*IEEE802.3cg TF*

*Changes to clause 147 and 148*

*January 22<sup>nd</sup>, 2018*

# PCS Receive State Machine amendments

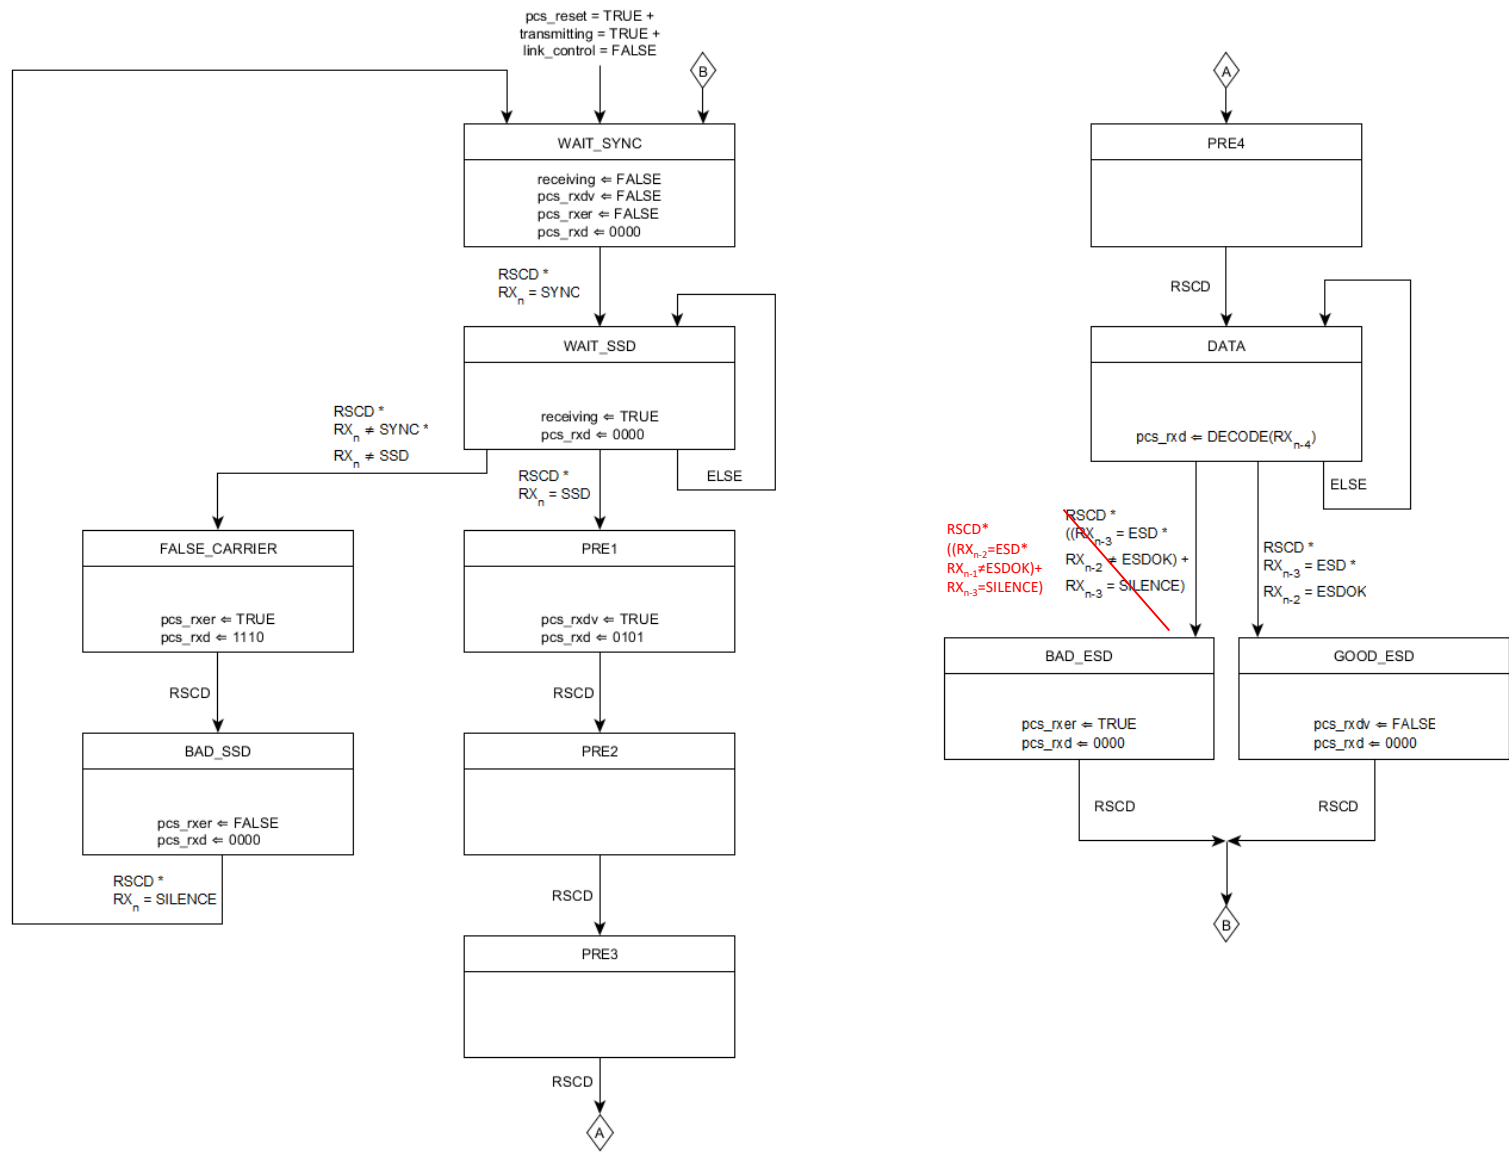
Where	What	Why
DATA -> BAD_ESD	detection of ESDERR anticipated by 1 RSCD	RX_ER shall be generated on the last valid data nibble. Otherwise an alignment error (odd number of nibbles) is reported by the MAC.

# PLCA DATA State Machine amendments

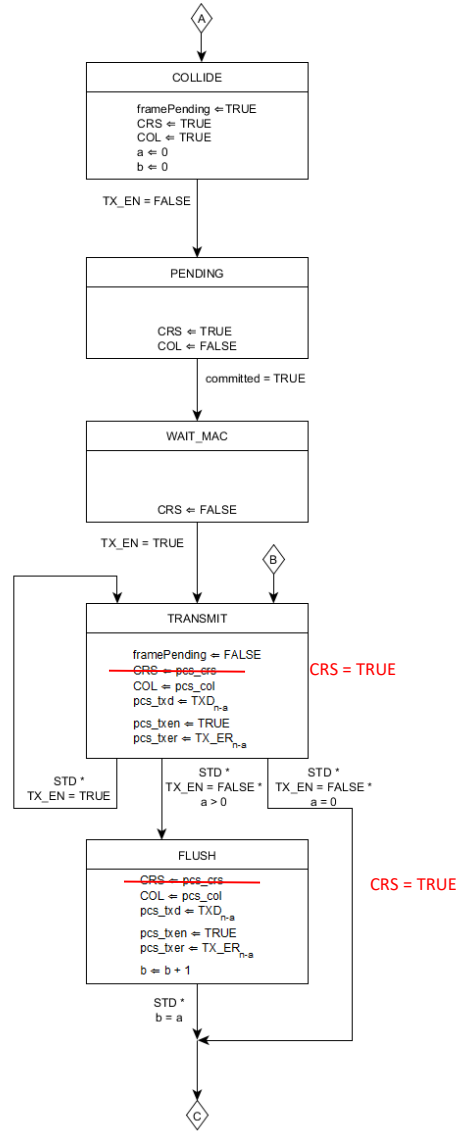
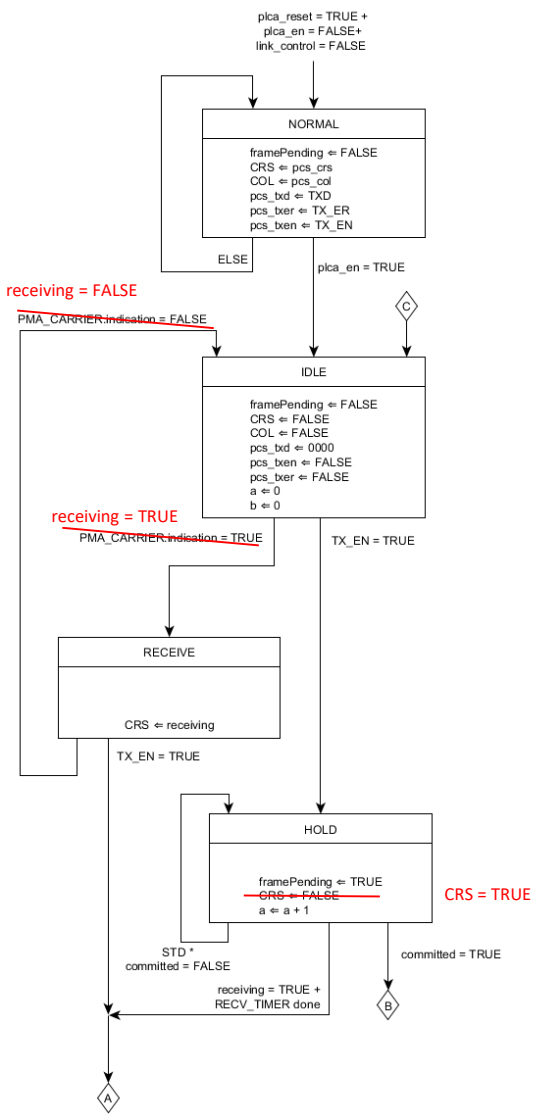
Where	What	Why
IDLE->RECEIVE RECEIVE->IDLE	state transition is triggered on “receiving”, instead of “PMA_CARRIER.Indication”	BEACON shall not trigger a state change
HOLD state	CRS = TRUE	CRS = FALSE might trigger aCarrierSenseErrors counting in MAC statistics (see 5.2.2) during logical collisions
TRANSMIT state	CRS = TRUE	CRS shall not be set to FALSE when entering TRANSMIT state from HOLD state
FLUSH state	CRS = TRUE	pcs_crs would be TRUE anyway
